ADDENDUM

JLG 24146-5 Dunn County Courthouse Renovation

Issued: November 13, 2025

ADDENDUM #: 03

4D
A212 SECTION AT HALLWAY 157 NS
SCALE: 1/4" = 1'-0"

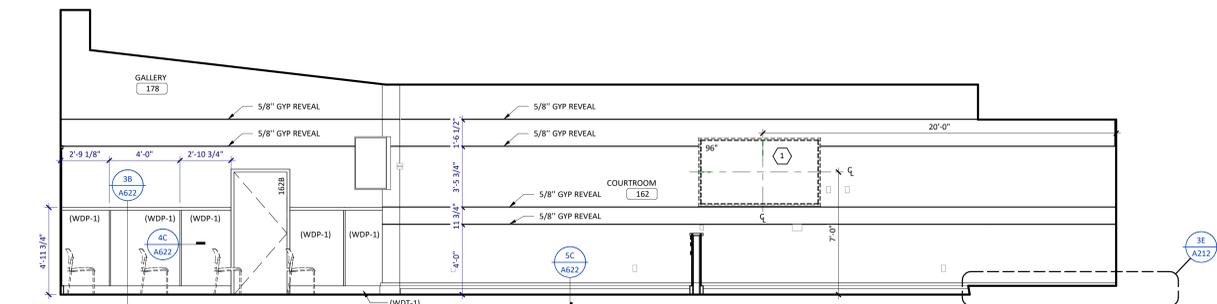
6. A212 – ENLARGED PLANS AND ELEVATIONS
 - Replace sheet in its entirety.
 - Added handrail reference to 4D/A212 SECTION AT HALWAY 157 NS
7. A213 – ENLARGED PLANS AND ELEVATIONS

4D
A213 ENLARGED STATE ATTORNEY RECEPTION
SCALE: 1/4" = 1'-0"

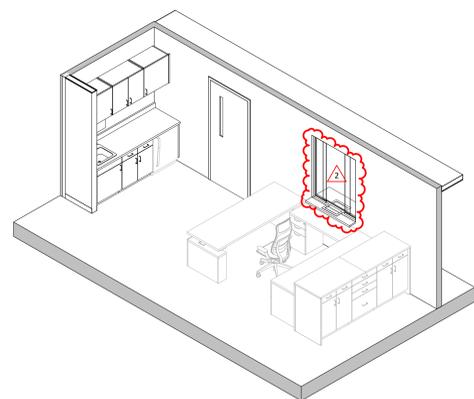
- Replace sheet in its entirety.
 - Removed drawings 3B/A213 and 9/A213.
 - Revised drawing 4D/A213 to show SF08 and dimension openings.
 - Added Floor Plan Keynote schedule for clarity.

SHEET **A303**
GLAZING DETAILS

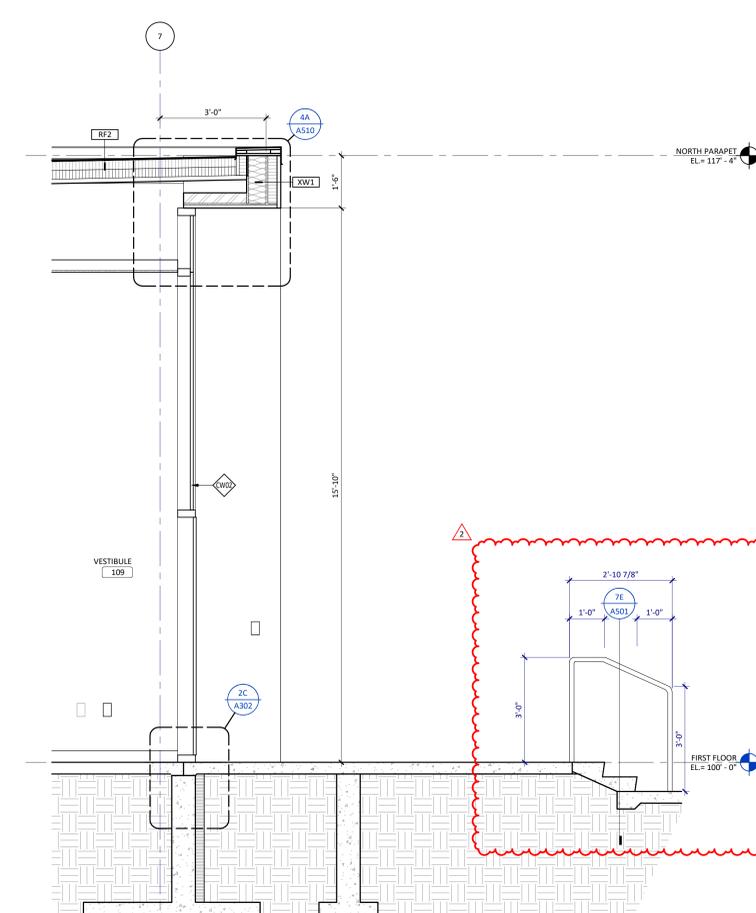
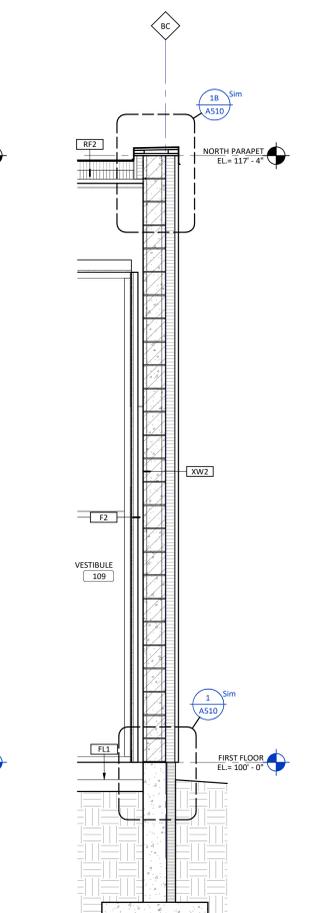
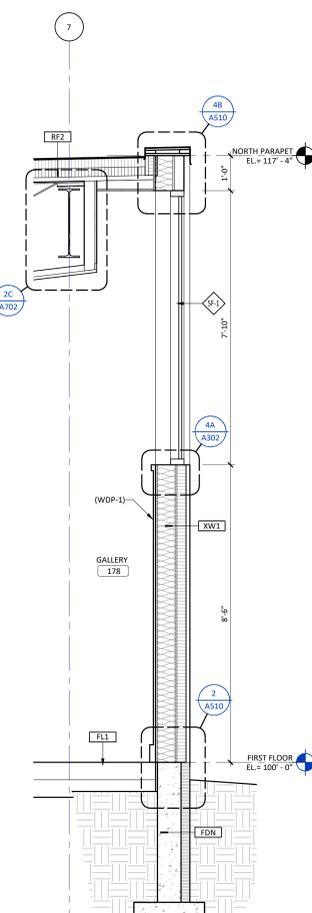
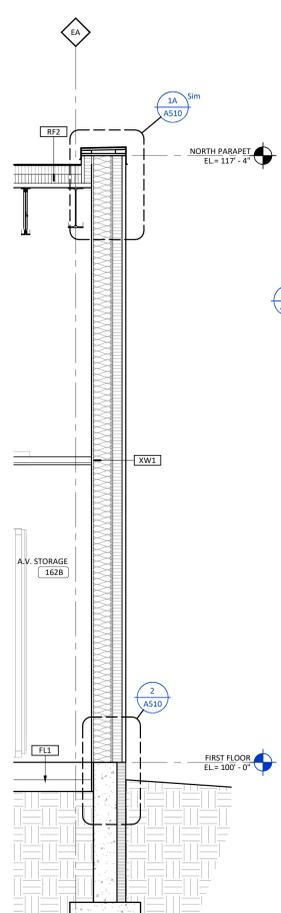
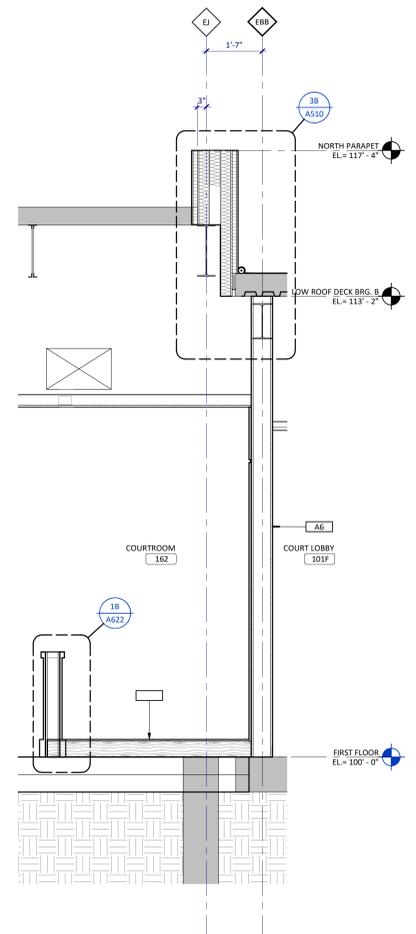
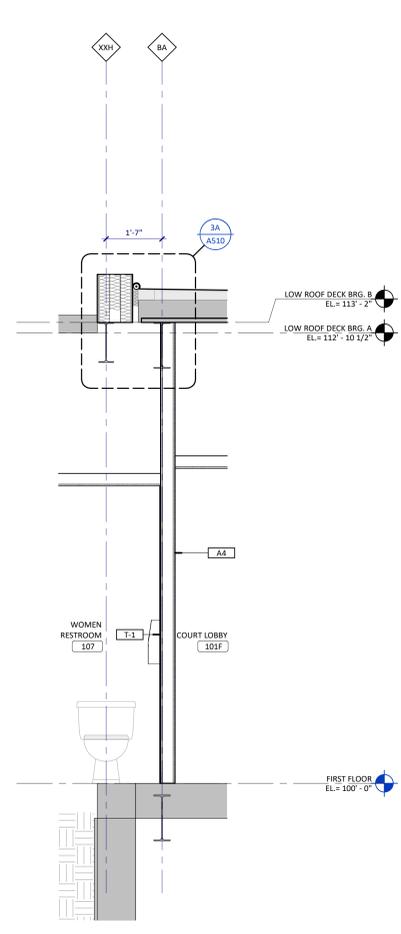
- Add sheet in its entirety.
 - Added details 2/A303, 3A/A303, 2B/A303, and 3B/A303 to reflect existing conditions.
 - Revised details 1A/A303, 1B/A303, 4A/A303, and 5B/A303 for clarity.

15 NOT USED
S301 1/2" = 1'-0"

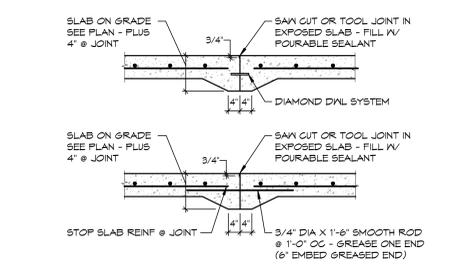
1. G100 - COVER SHEET
 - o Revised sheet index to show added sheet A303.
2. S301 - FOUNDATION DETAILS
 - o Replace sheet in its entirety.
 - o Detail 15/S301: Detail no longer needed. Detail Removed.
3. S401 - FRAMING DETAILS
 - o Replace sheet in its entirety.
 - o Detail 1/S401: Clarified base plate and anchor rod requirements.

| 45 | Courthouse | 15/S301 | 11/06/25 | 11/13/25 | Drywall | Is there a condition where 15/S301 is intended to be utilized at the Courthouse? | No. Intened wall removed from plan. Detail removed in Addendum #3. |
